**Re: Viking Sales and Service Center (SP-21-17)**

Pursuant to comments received from staff on Friday, January 7, 2022, please accept this letter as a written response. Also included, are revised plans and documents which address the comments where applicable.

3. C500/501

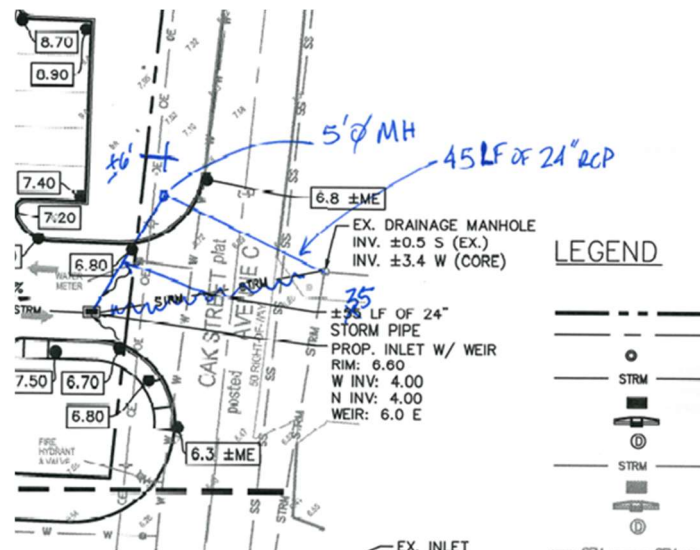
- c. The proposed drainage connection north of 16th Street along Avenue C requires realignment as shown below. In addition, the open cut across Avenue C requires a 1" mill and overlay 25' north and south of the extents of the open cut.

**Response: The pipe connection is no longer proposed within the project limits therefore this comment is no longer applicable.**
